Department of Energy

ROCKY FLATS OFFICE P.O. BOX 928 () GOLDEN, COLORADO 80402-0928 013194-5

93-DOH-00582

The U.S. Department of Energy, Rocky Flats Office (DOE/RFO) has reviewed the data aggregation methodology attached to the U.S. Environmental Protection Agency, Region VIII, (EPA) and Colorado Department of Health's January 11, 1994 letter to DOE/RFO regarding the lifting of the stop work order. Our primary concerns are as follows:

FIGURE 1: ILLUSTRATION OF SOURCE AREAS AND STATISTICAL APPROACH

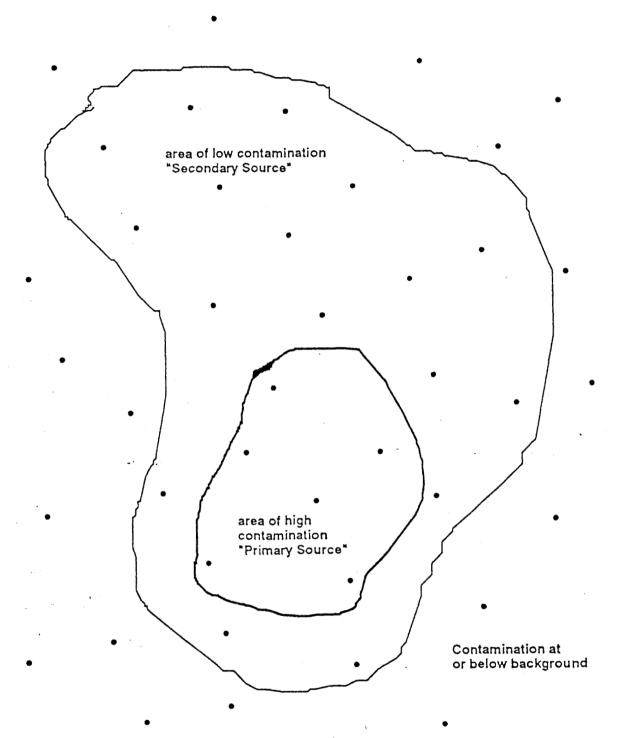
Figure 1 is an illustration of the potential for significant variability of data in the original source area.

The large area has a total of 23 data points which when tested against background were found to be statistically significant. These 23 locations and the associated concentrations for a particular contaminant were then considered to be the "source" area. Once the "source" area was defined the procedures for calculating the concentration term are followed as modified in this proposal. The total data set of 23 points is tested for normality (or more appropriately log-normal distribution). In this particular case the probability plot was found to exhibit significant non-linearity (condition for non-normal data). The next step was to determine the significant contributors to the non-normal conditions. This is accomplished by testing for outliers and then using these results as a separate population and performing a non-parametric ANOVA or other appropriate test for differences in means, medians, or variance. This determination resulted in the identification of six data points which when combined together exhibited near normal, when the data was appropriately transformed, conditions and the remaining 17 data points also exhibited normality. The ANOVA performed to test the difference in the means of these two populations showed results that indicated the means were significantly different and hence were probably two different populations.

It is important to note that the appropriate statistical tests (normality) need to be performed on the subset of the original data to ensure that the most significant contributors to non-normality are identified.

It is also important to note that in this example the small subset of the original data (comprised of 6 data points) was clustered together both spatially and temporally. Also for the purposes of this example the small subset of the original data are significantly greater in concentration than the remaining data points, which resulted in the determination that the data set actually contained two separate populations. The difference cannot be stated as a definite multiplier, however the expected difference in the means would be an order of magnitude or more otherwise the statistical analysis would not have indicated different populations.
